**ADDENDUM NO 2
TO
CONTRACT DOCUMENTS
FOR
JORDAN VALLEY WATER TREATMENT PLANT RECLAIM WATER AND SOLIDS
HANDLING IMPROVEMENTS**

[DISTRICT PROJECT NO.: 4072]

August 21, 2020

JORDAN VALLEY WATER TREATMENT PLANT
RECLAIM WATER AND SOLIDS HANDLING IMPROVEMENTS
TYPICAL DETAILS
CIVIL TYPICAL DETAILS 2

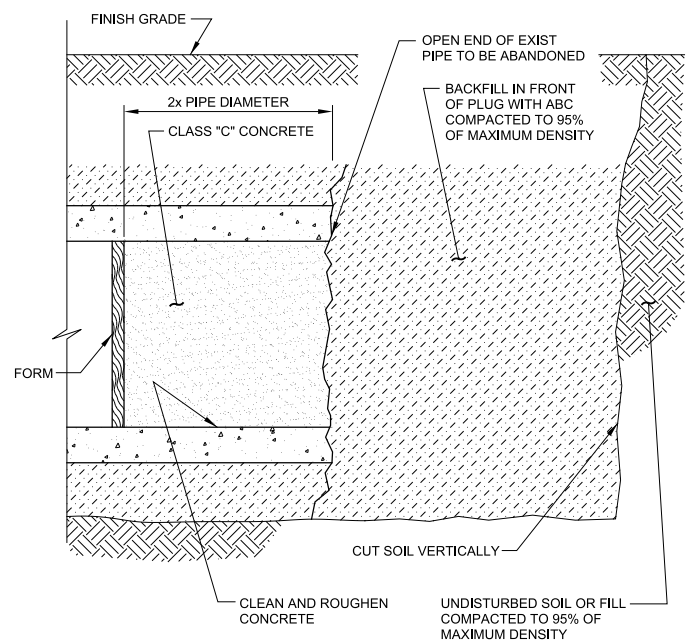
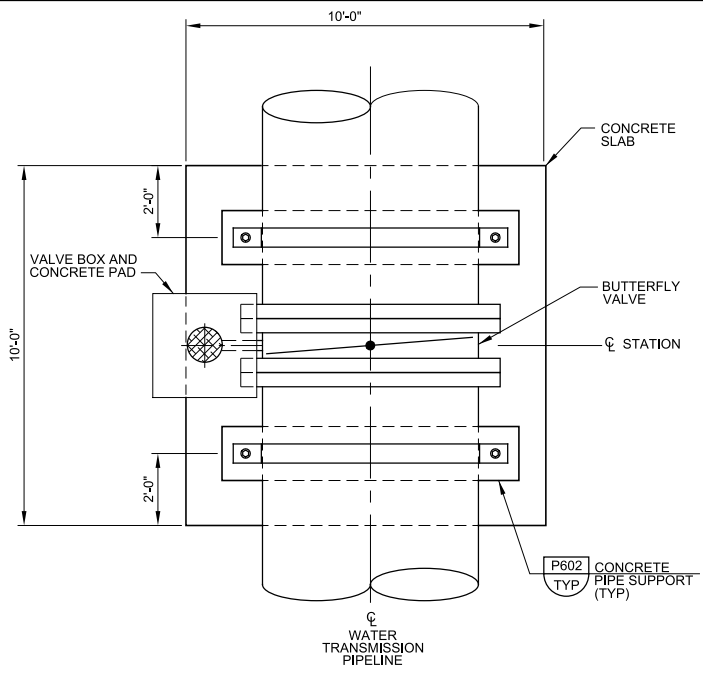
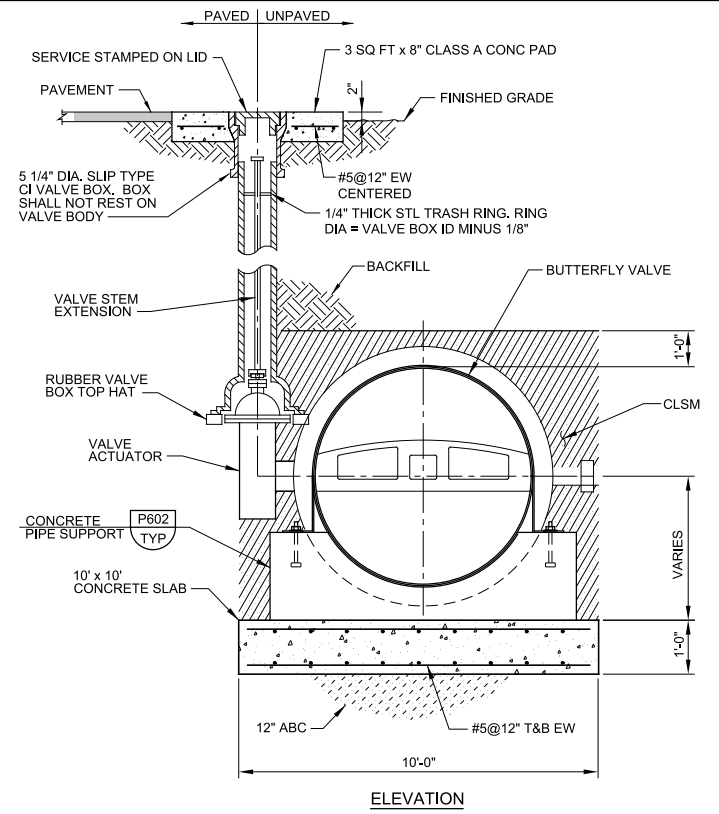
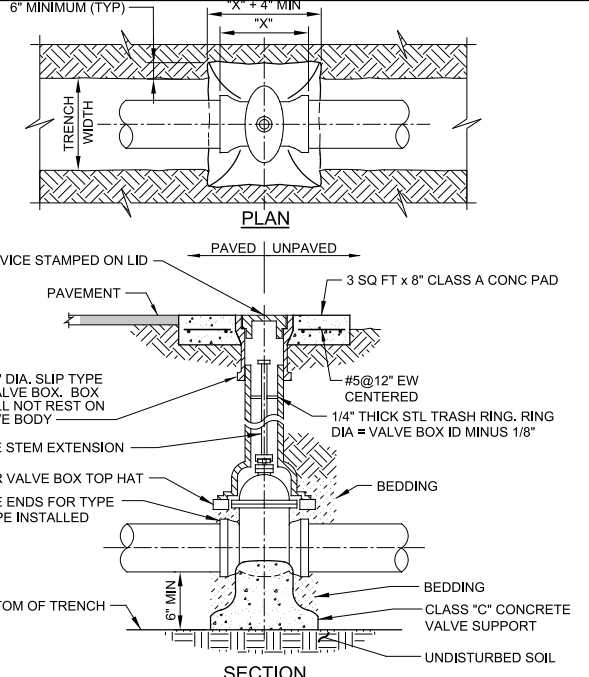
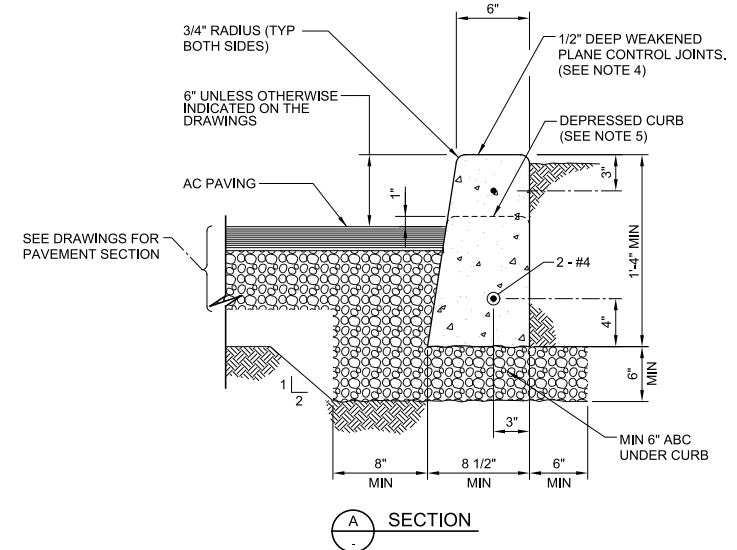
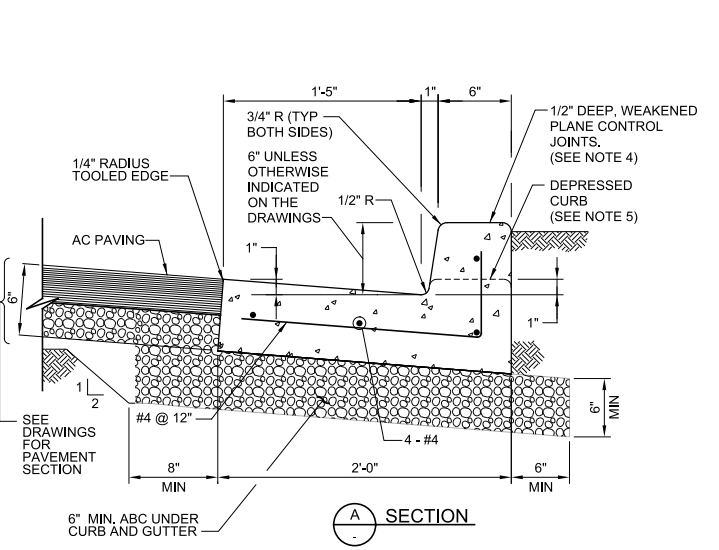
- A. Drawing TC02 CIVIL TYPICAL DETAILS 2
 - 1. Replace drawing in its entirety with the attached drawing.
- B. Drawing C11 PAVEMENT PLAN
 - 1. Add attached drawing in its entirety.
- C. Drawing C12 PAVEMENT SECTIONS
 - 1. Add attached drawing in its entirety.
- D. Drawing GS01 GENERAL STRUCTURAL NOTES
 - 1. Replace the date "April 2020" with "June 2020".
 - 2. Replace Sheet No. "22 OF 69" with "23 OF 70".
- E. Drawing 2S01 WEIR VAULT - LOWER AND UPPER PLANS
 - 1. Replace the date "April 2020" with "June 2020".
 - 2. Replace Sheet No. "23 OF 69" with "24 OF 70".
- F. Drawing 2S02 WEIR VAULT - SECTIONS
 - 1. Replace the date "April 2020" with "June 2020".
 - 2. Replace the Sheet No. "24 OF 69" with "25 OF 70".
- G. Drawing N01 SYMBOLS AND ABBREVIATIONS - I
 - 1. Replace valve tag "VAL 441" with "VAL 4441".
